Hi-Fi Products Service Bulletin

Model: SEQ-711

No. 413

Subject: Correction of IC421 Block Diagram

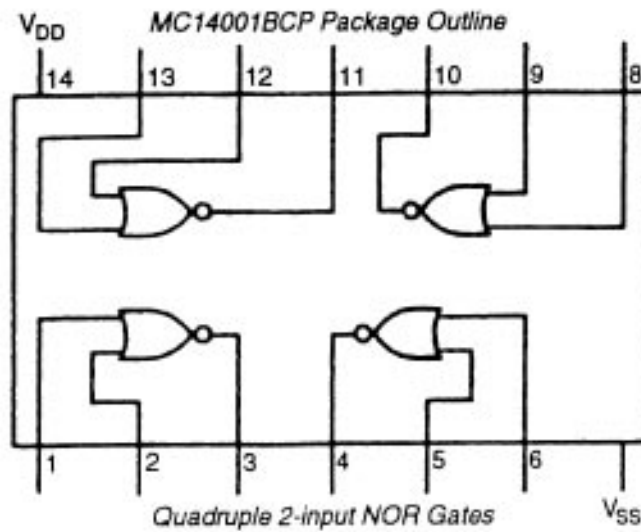
The block diagram of IC421 (MC14001BCP) is shown incorrectly on page 13 of the Service Manual.

Solution: The correct block diagram is shown below.
